# Notes from the 9<sup>th</sup> IWG ACPE meeting in Seoul, 19.06. – 21.06.2024

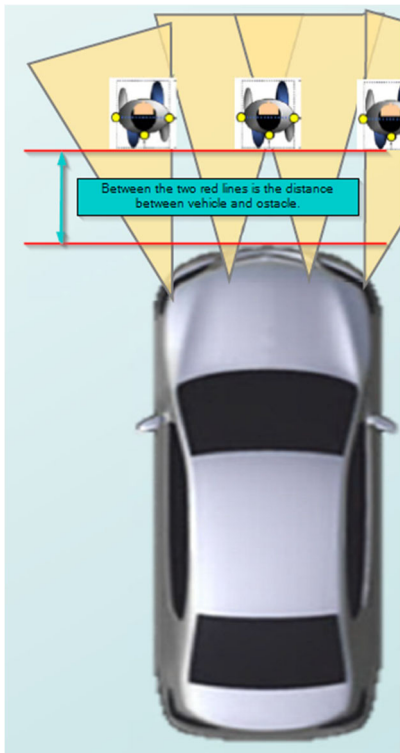
UK proposed child dummy as target.

Wording is not clear.

6.5.1. measuring the distance between vehicle and pedestrian is not clear.

NCAP wording is clearer. Will be copied from there.

Copy wording from R159. See the [clarification](#) in the figure:

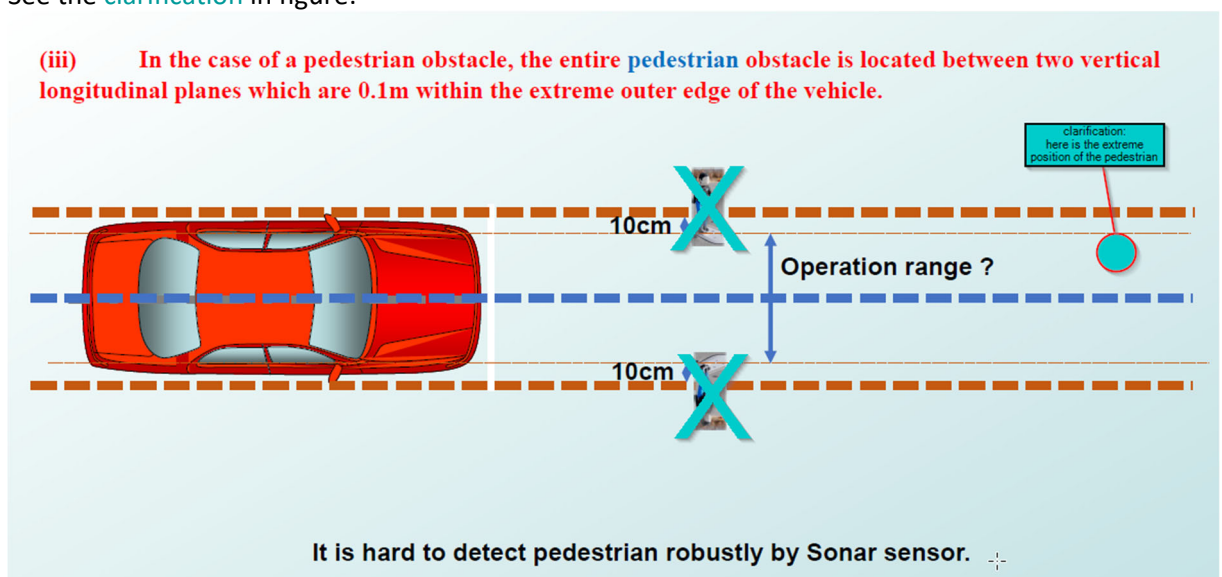
Please clarify that under 5.1.4. the industry position is 3 or 4 km/h.

Proposals for 5.1.4. should be discussed in the next meeting.
